CITY OF REDONDO BEACH
DEPARTMENT OF ENGINEERING AND BUILDING SERVICES
ADDENDUM

Date: September 13, 2012
To: All Bidders
From: City Engineer / Chief Building Official
Subject: **Addendum No. 1 – Veterans Park Community Center Condenser/ HVAC Replacement Project, Job No. 20500**

EXHIBIT-A

Addendum No. 1
Veterans Park Community Center Condenser/HVAC Replacement Project, Job No. 20500

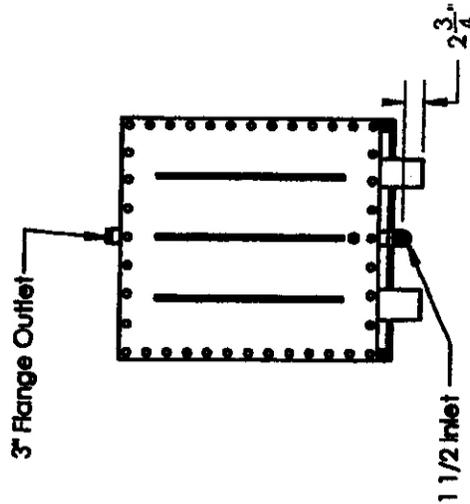
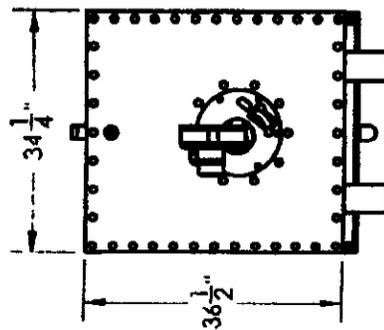
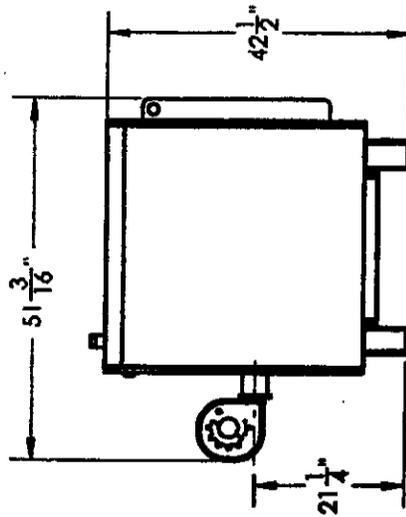
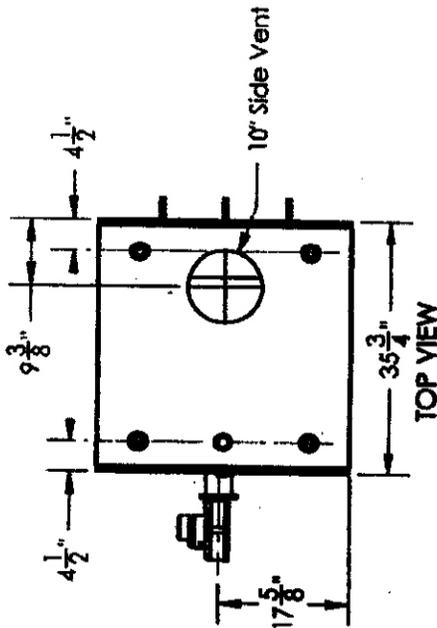
7. The City is responsible for providing and installing new chain link double doors for the condensing unit enclosure.
8. On Sheet M-3, at the Point of Connection for the new boiler, the symbol attached to the right of the boiler is the burner blower of the design based Ajax boiler, see attached EXHIBIT- A.
